## Northville DDA Economic Development Committee

## Preliminary Site Plan/PUD Review For City of Northville, Michigan

<b>Applicant:</b>	Hunter Pasteur Northville LLC 32300 Northwestern Highway, Suite 230 Farmington Hills, MI 48334
<b>Project Name:</b>	The Downs Planned Unit Development (PUD)
<b>Plan Date:</b>	December 15, 2021
<b>Latest Revision:</b>	January 20, 2022
<b>Location:</b>	Vacant parcels on the south side of Cady St. (between S. Center and Griswold), the Northville Downs racetrack property south of Cady St. (between S. Center St. and River St.), and two areas on the west side of S. Center St.
<b>Zoning:</b>	CBD – Central Business District CSO – Cady Street Overlay District RTD – Racetrack District R-2 – Second Density Residential District
<b>Action Requested:</b>	Preliminary Site Plan/PUD Review
<b>Required Information:</b>	As noted within this review

1 Section Through NW Building/  
Cady Street/Main Street

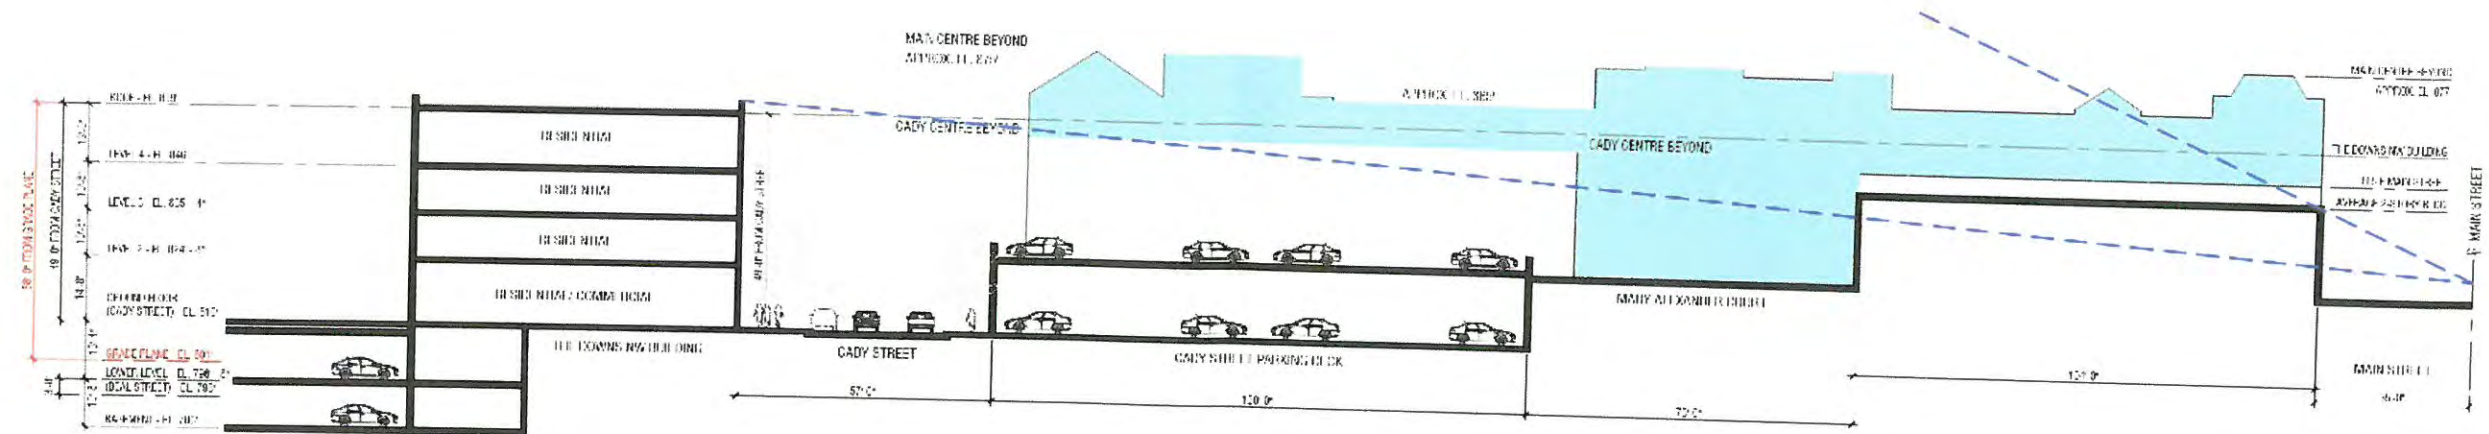
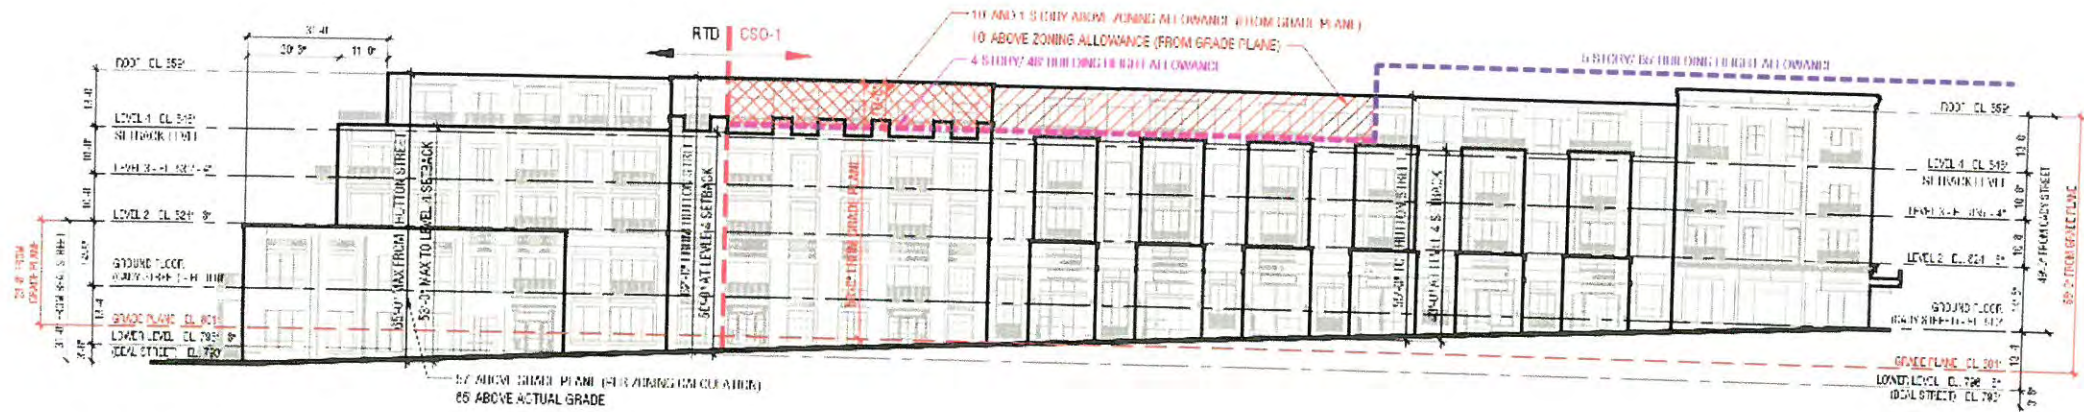
- vii. Applicant to confirm that cross section shown (PUD Eligibility Pre-App Site Plan Full Set, Sheet 8: Building Height Diagrams - 2 of 2; *Detail 1: SECTION THROUGH NW BUILDING/ CADY STREET/ MAIN STREET*) is accurate. The Commission questions that Main St. is one full story below Mary Alexander Court. This information needs to be provided. *This detail was revised in the most recent submission, and is shown on Sheet A0.2.*
